AERONAUTICAL CHARTING FORUM
Instrument Procedures Group
April 28, 2009
HISTORY RECORD

FAA Control # 09-01-282

Subject: Glide Slope Intercept Altitudes on ILS Parallel Approaches

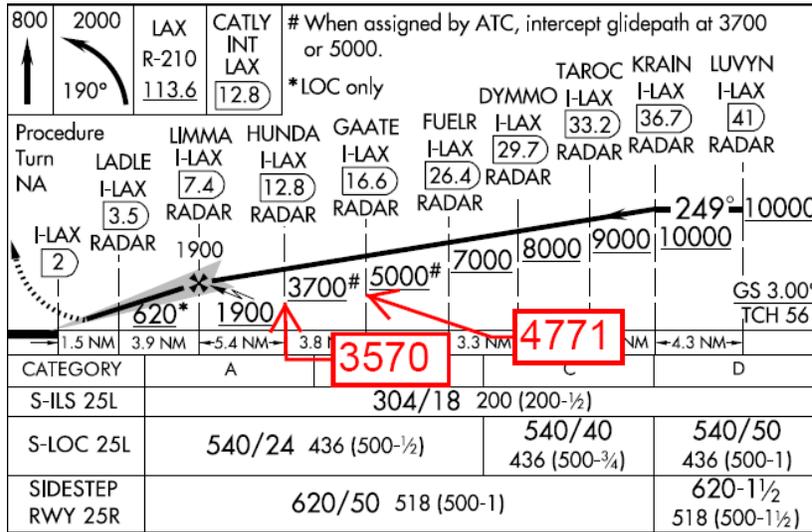
The note advises the pilot to intercept the glidepath, but fails to address the applicability of the published step-down fix minimum altitudes that are encountered during the subsequent descent. Interception of the glidepath (ILS glide slope) does not necessarily ensure that subsequent step-down fixes will be crossed at or above the published minimum crossing altitude, which is an expectation that is stated in AIM 5-4-5 (b)(1). An example of this situation may be seen on the ILS 25L at Los Angeles, CA (LAX) which is depicted below. The estimated ILS glide slope MSL crossing altitudes depicted by red boxes:

NBAA is concerned that lacking sufficient guidance on the instrument procedure chart and in the AIM, the pilot may cease tracking of the glidepath if he/she perceives that the aircraft will descend below the published step-down fix minimum altitude. This may result in not achieving the required altitude separation expected by ATC during simultaneous ILS approach operations. NBAA is also concerned about a pilot's understanding of the implications of an ATC assignment to intercept glidepath at an altitude other than the glide slope interception altitude as noted on the IAP and how this relates to the final approach fix location. The "lighting bolt" symbol depicted on US Government charts provides two critical pieces of information to the pilot.

- Revise the note to clearly state the applicability of subsequent step-down fix altitudes when the glidepath is intercepted prior to the published glide slope intercept altitudes as follows:

“When assigned by ATC, intercept and track glidepath. Disregard subsequent step-down altitudes.”

ILS or LOC APPROACH

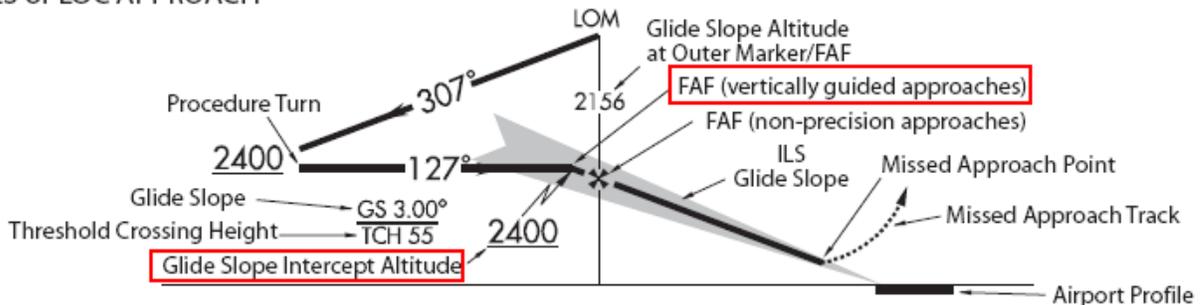
First, the "lighting bolt" depicts the glide slope intercept altitude and the precise final approach fix (PFAF), which is the point where the aircraft enters the final approach segment as defined by US TERPS and established for the particular ILS instrument approach procedure by 14 CFR Part 97.

Second, it defines the beginning of the final approach segment where the weather minimums established by 14 CFR 121.651 and 14 CFR 135.225 must be met for the pilot to continue the approach to landing.

It must be understood that even though the glidepath was intercepted above to the depicted glide slope intercept altitude, the PFAF remains fixed at the published glide slope intercept altitude in accordance with Part 97. Further, even if the pilot is cleared by ATC to intercept the glidepath early, the requirements of 121.651 and 135.225 are **not** triggered until aircraft reaches the glide slope intercept altitude, i.e., reaching the PFAF, as published on the instrument approach procedure.

When noted on the instrument approach procedure, ATC may assign an aircraft to intercept and track the glidepath prior to the depicted glide slope intercept altitude. When assigned by ATC, pilots are expected to intercept and track the glide slope and disregard minimum, maximum, and mandatory altitudes depicted for subsequent step-down fixes. However, the final approach fix and the beginning of the final approach segment remain located at the published glide slope intercept altitude as depicted by the “lighting bolt” symbol on US Government charts.

SEATTLE-TACOMA INTL (SEA)
ILS or LOC RWY 16L

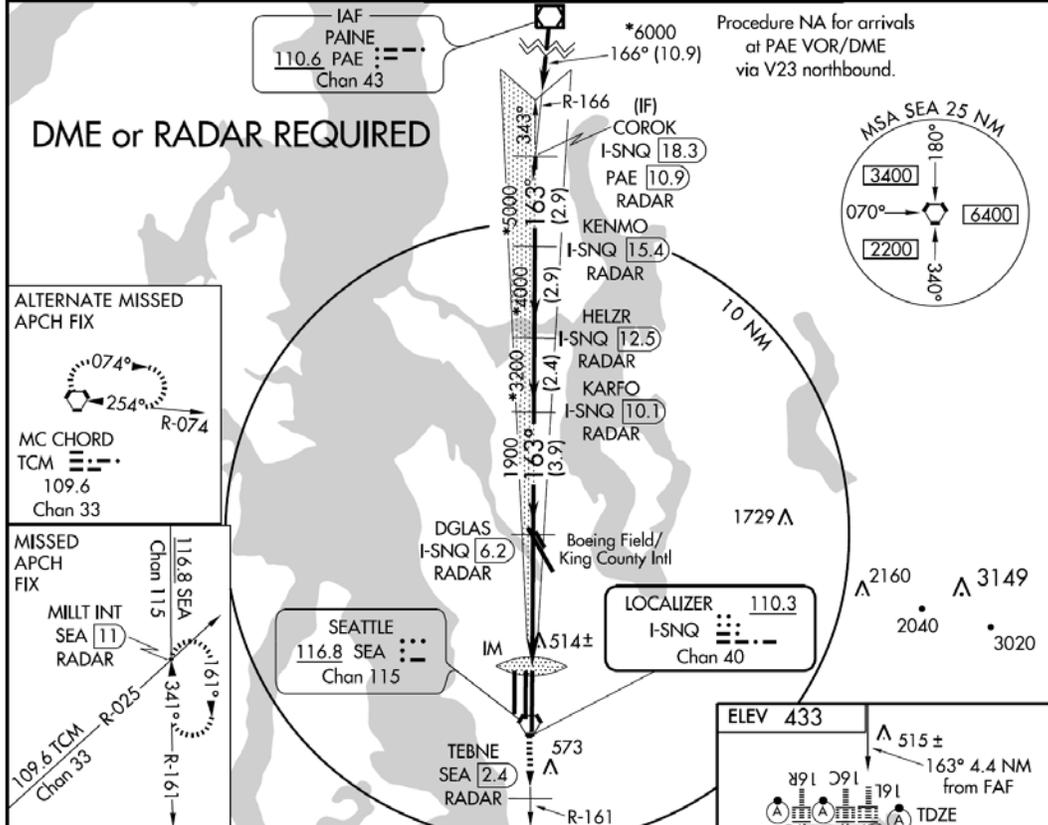
Finally, NBAA is concerned about the need to publish each altitude where ATC may authorize a pilot to intercept the glidepath. We feel that this needlessly clutters the chart profile view. We question whether it is necessary to identify each step-down crossing altitude where ATC may assign a clearance to intercept and track the glidepath. Please see attached examples for LAX ILS 25L and SEA ILS 16L approaches

* When assigned by ATC, intercept glidepath at 3200 or 4000 or 5000 or 6000.			
COROK I-SNQ 18.3 RADAR	KENMO I-SNQ 15.4 RADAR	HELZR I-SNQ 12.5 RADAR	KARFO I-SNQ 10.1 RADAR
DGLAS I-SNQ 6.2 RADAR		TEBNE SEA 2.4 RADAR	
MILIT INT SEA 11 RADAR		5000 SEA R-161	
*6000 163°			
*5000 163°			
*4000 163°			
*3200 163°			
GS 3.00% TCH 54 Procedure Turn NA			
-2.9 NM		-2.4 NM	
-3.9 NM		-3.3 NM	
-1.1 NM		0.1 NM	
CATEGORY	A	B	C D
S-ILS 16L	695/18 262 (300-½)	633/18 200 (200-½)	
S-LOC 16L	880/24 447 (500-½)	880/40 447 (500-¾)	880/50 447 (500-1)
CIRCLING	1000-1 567 (600-1)	1000-1½ 567 (600-1½)	1000-2 567 (600-2)
ELEV 433			
A 515 ±			
163° 4.4 NM from FAF			
TDZE 433			
TWR 606 A			
696			
517			
593 A			
HIRL all Rwys			
TDZ/CL Rwys 16L, 16C, 16R and 34R			
FAF to MAP 4.4 NM			
Knots	60	90	120 150 180
Min:Sec	4:24	2:56	2:12 1:46 1:28
